ETHOS URBAN

DA 2020/567 – 7 MARTIN CLOSE AND 42 STRONACH AVENUE, EAST MAITLAND SECTION 4.55(2) MODIFICATION APPLICATION

On behalf of Churches of Christ (Fresh Hope) we hereby submit an application pursuant to section 4.55(2) of the *Environmental Planning and Assessment Act 1979* (EP&A Act) to modify DA/20/567 approved on 9 April 2021 relating to the redevelopment of the existing Greenhills residential aged care facility.

Figure 2 Proposed aviary location outlined red

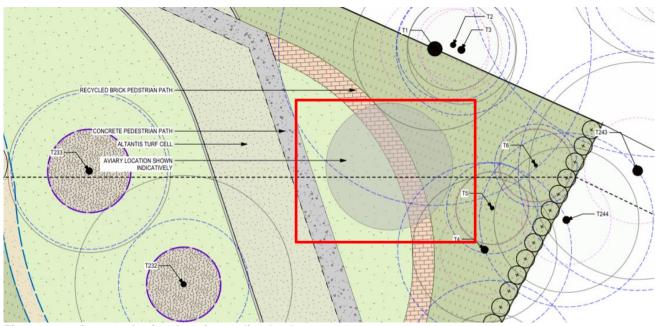
At the site's north-eastern corner, adjacent to the interface with 44 Stronach Avenue, the proposed modification seeks to introduce a new aviary. The aviary will have an area of $17m^2$. At its interface with 44 Stronach Avenue, a 3m callistemon hedge will provide separation and a buffer between the aviary and existing dwelling. The total setback from the boundary of 44 Stronach Avenue will be 6m. This will be in addition to the 1.8m high fence on the boundary of the existing property.

The indicative location and elevation of the aviary is shown at Figure 2 and Figure 3.

Figure 4 Proposed materials schedule
Source: Calderflower Architecture

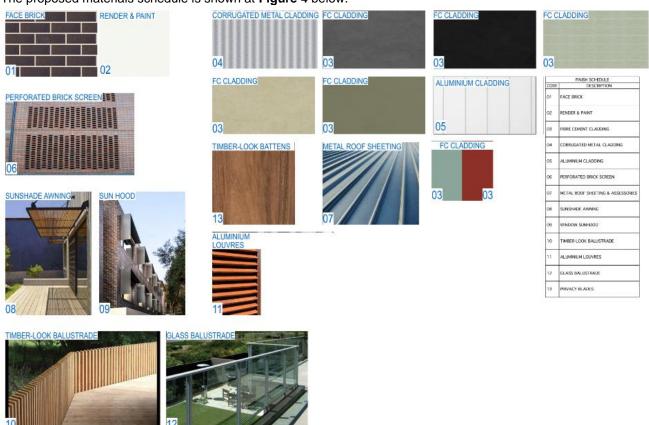
The proposed modification seeks to amend the materials schedule as a result of further design refinement and to improve the architectural design of the RACF development, integrating it with the surrounding landscape and adjoining development. The fenestrations and materiality generally remains unchanged from that which was previously approved, however, the proposal now seeks to incorporate warm, earthy tones and finishes to reflect the surrounding area.

The proposed materials schedule is shown at Figure 4 below.
